SEWAGE DISPOSAL TESTING

SUBDIVISION Triadelphia Farms II LOT NO. 7B
13270 ROAD AND DESCRIPTION Triadelphia Road

PLOT PLAN
LOT 7B

TITLE PERCOLATION TEST PLAT			
PROJECT LOT 7A, 7B, 7C & 7D TRIADELPHIA FARMS II			
LOCATION 3RD ELECTION DISTRICT		HOWARD COUNTY, MD.	
DATE: JULY, 1979	DESIGN BY: -	DRAWN BY: W.H.N.	CHECKED BY: W.G.H.
SCALE: 1" = 100'	JOB NO.: 77228	DRAWING NO.: 1 OF 1

TRIDELPHIA FARMS II Lot 7B

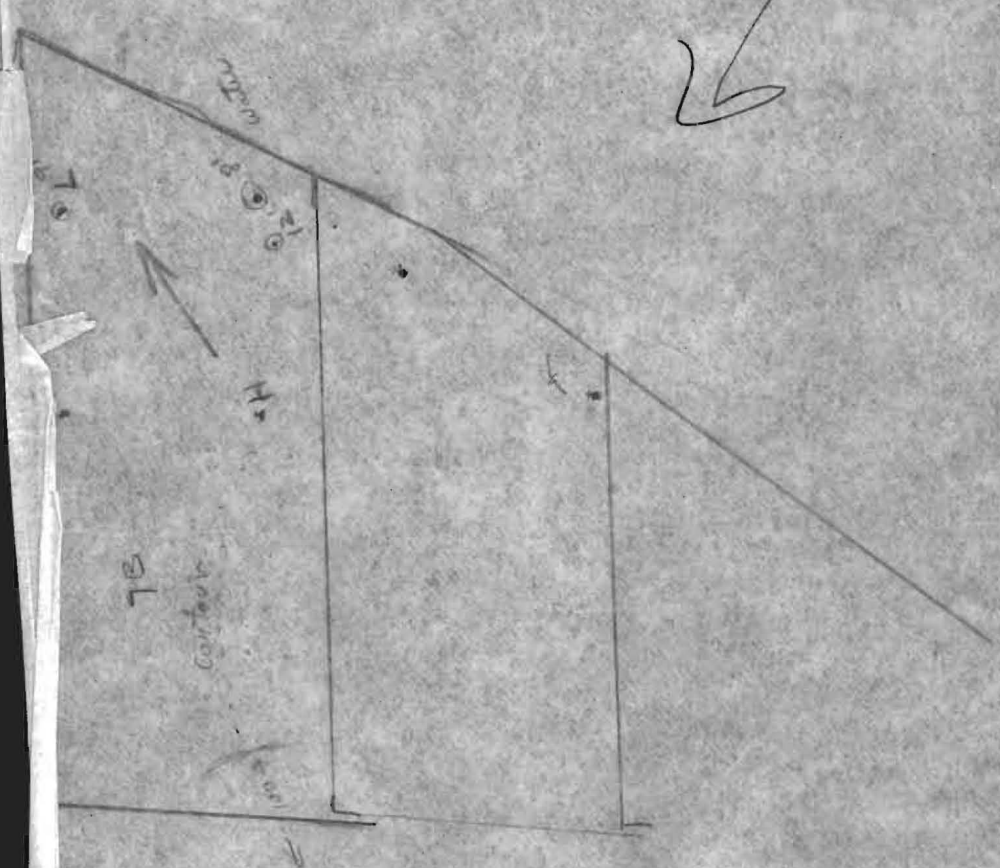
HOLD PENDING FURTHER TESTS in wet season only F. Skinner DATE 6/29/78

REASONS FOR REJECTION OR HOLDING Water at 8 to 11' in low perc test hole to

2/2/79 - HOLD FOR REVIEW WATER IN 1978 R17 2/21/79
perc time OK but need certified Hole House Site Well site Field
Run Top R17

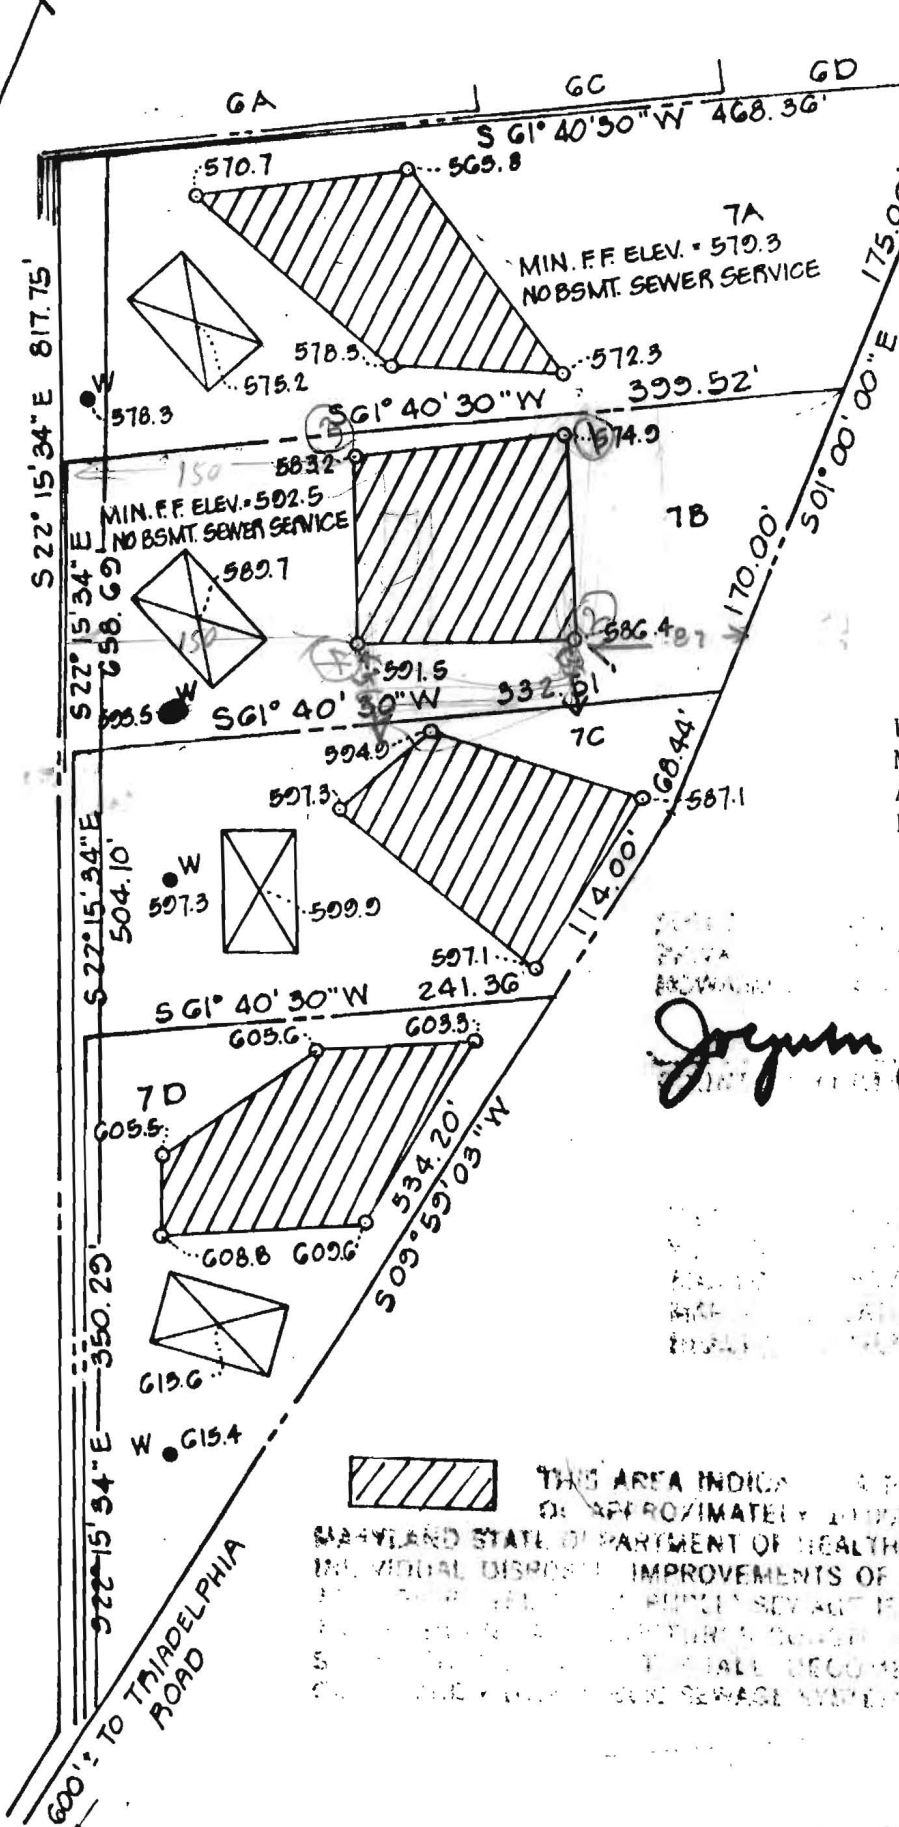
11/1/83
Sketch OK.
J.S.

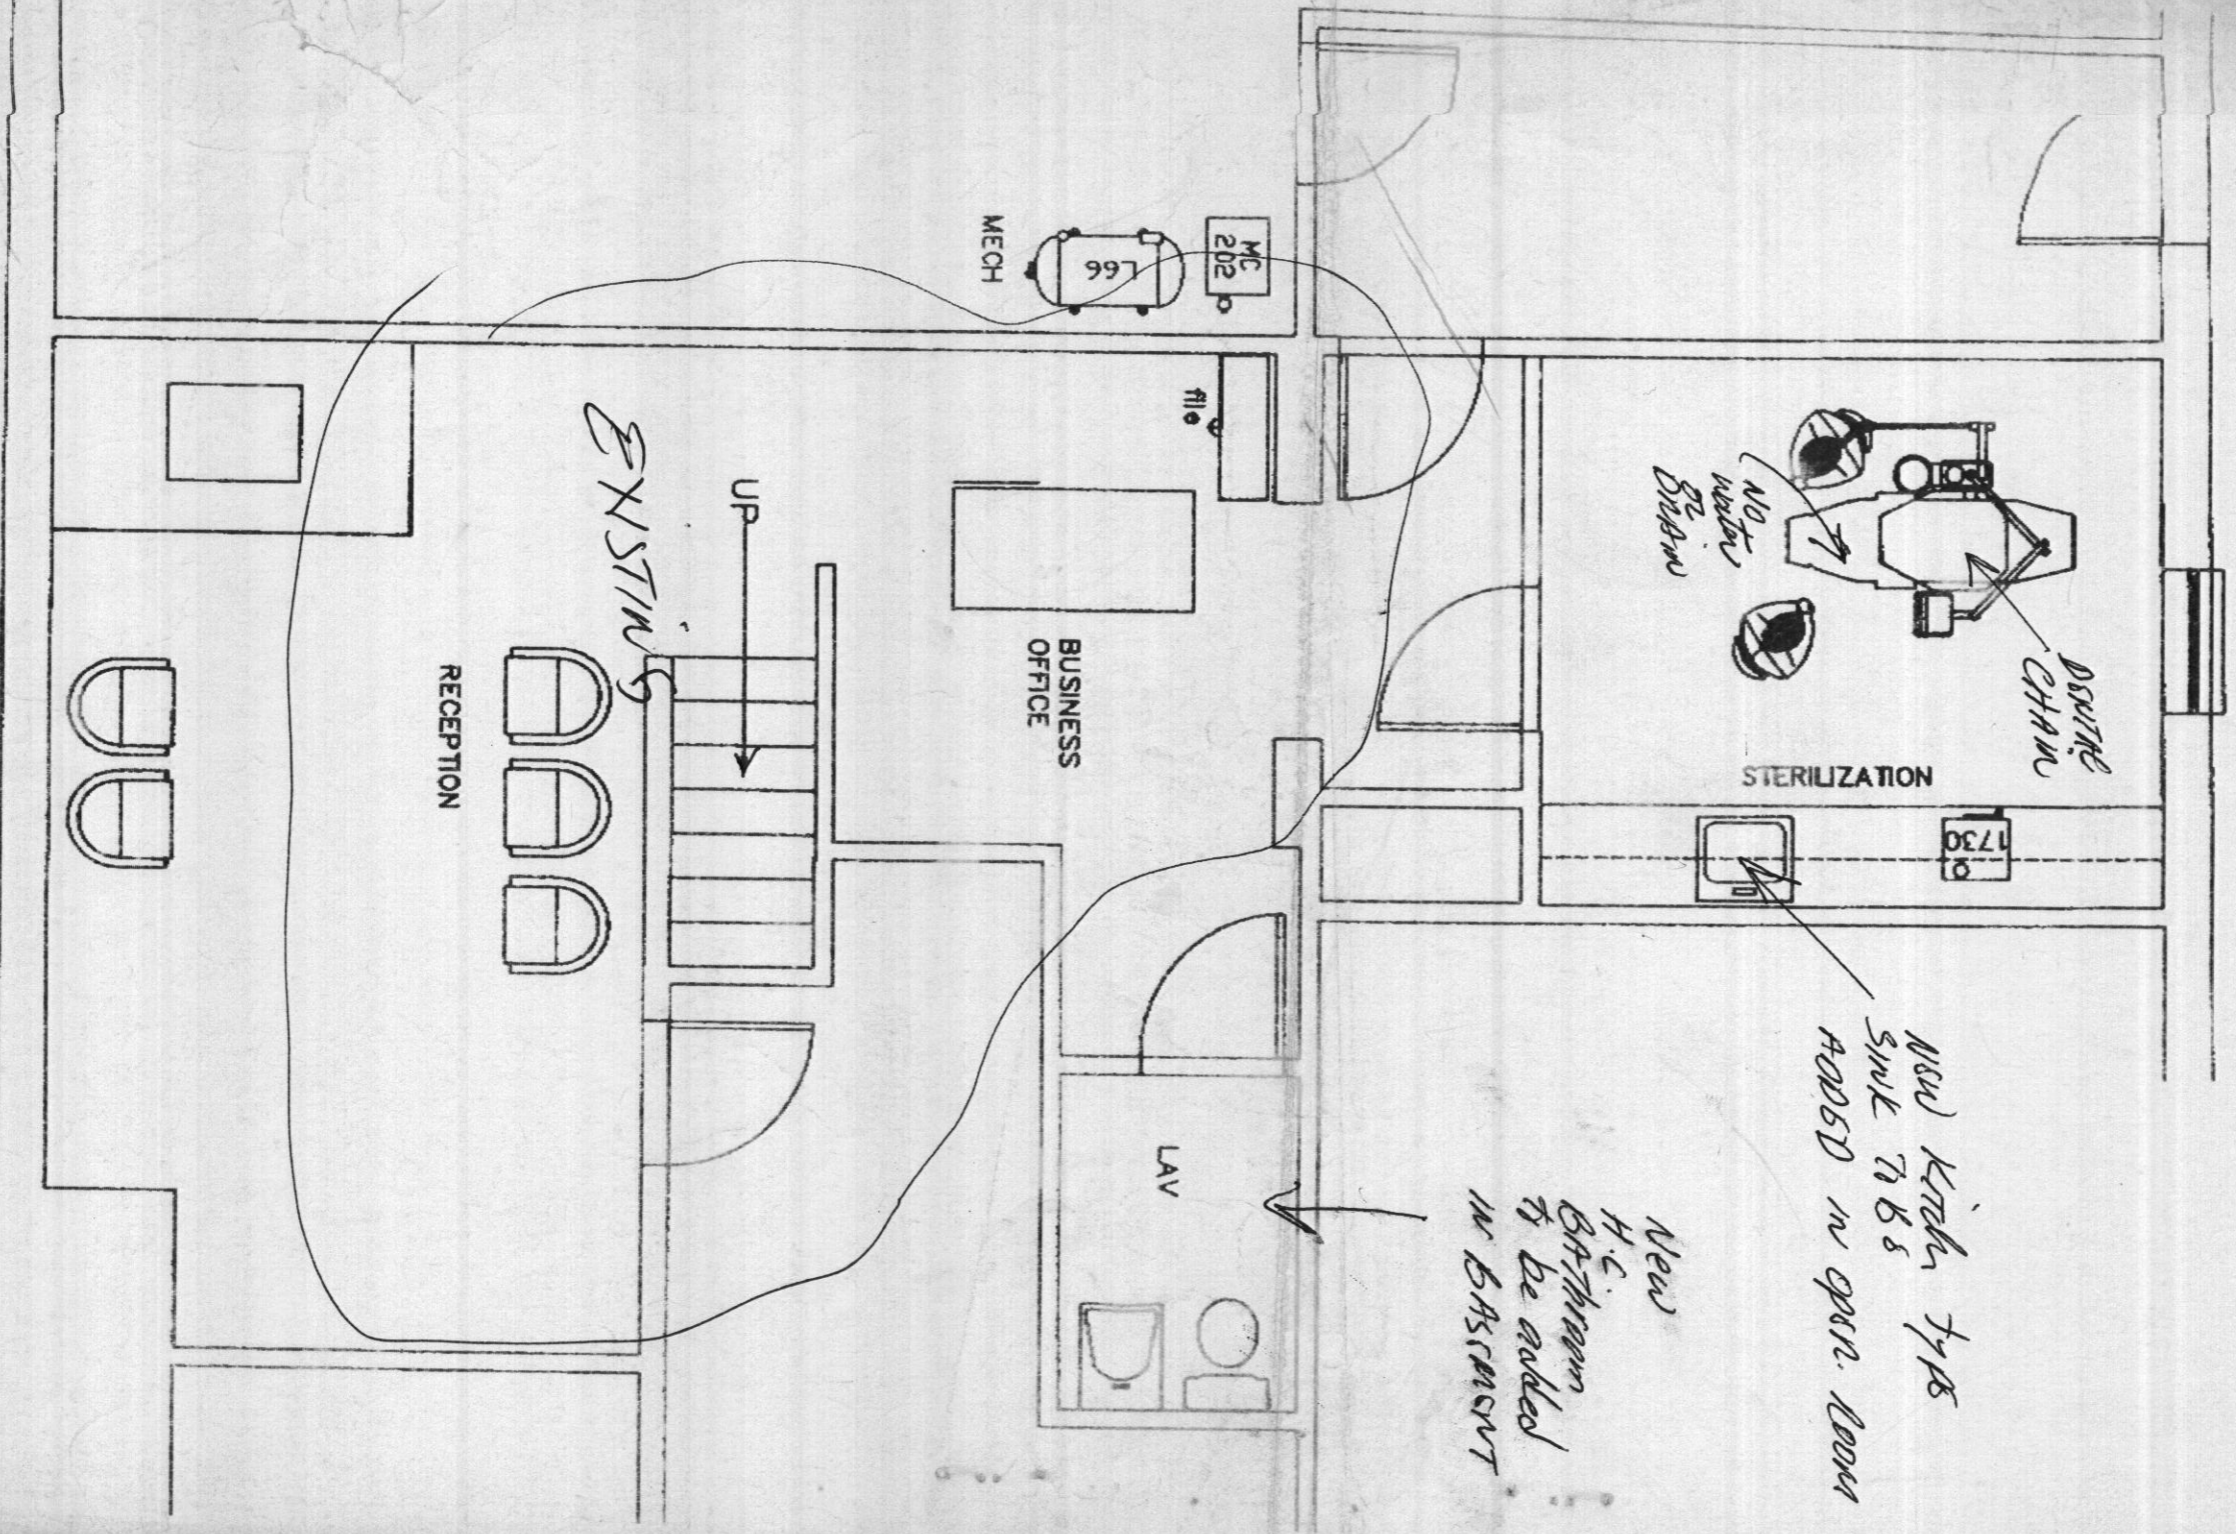
New kitchen type sink TBs added in oper. room

New H.C. Bathroom to be added in basement

AS DISCUSSED WITH D, SUN
ACCEPTABLE WITH NO REQUIREMENT
FOR ADDITIONAL SEPTIC CAPACITY
AT THIS TIME.
SEPTIC AREA IS SUITABLE
